UniversityCity Prosperity Project BT-904

Request for Design-Build Proposals

Addendum 1

October 9, 2014

INDEX OF PROJECT PLANS

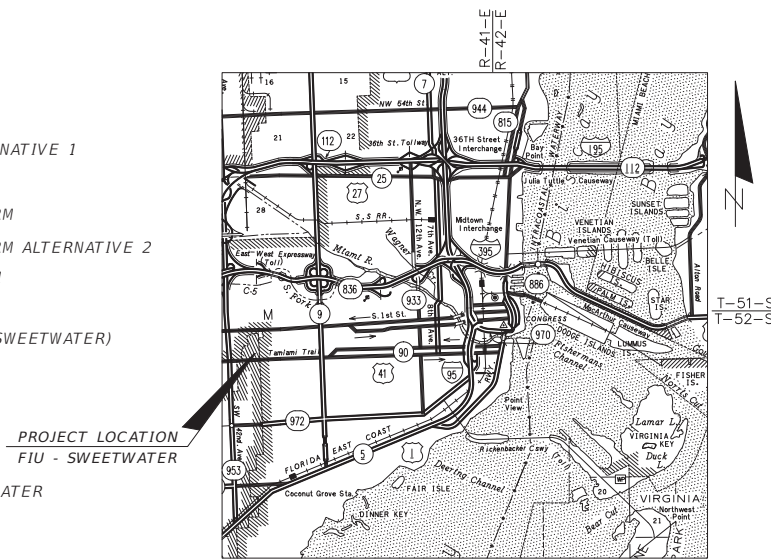
Question 7. The Concept plans Key Sheet indicates there are sheets 22 and 23. However these sheets are missing from the final pdf. Please provide.

Response to Question 7. - Sheets 22 and 23 of the Conceptual Plans were deleted prior to issuance of the RFP. Please correct the Index of Project Plans on Sheet 1 accordingly. A substitute sheet will also be issued as part of this Addendum. Confirmation of receipt by Design-Build Firms will be required.
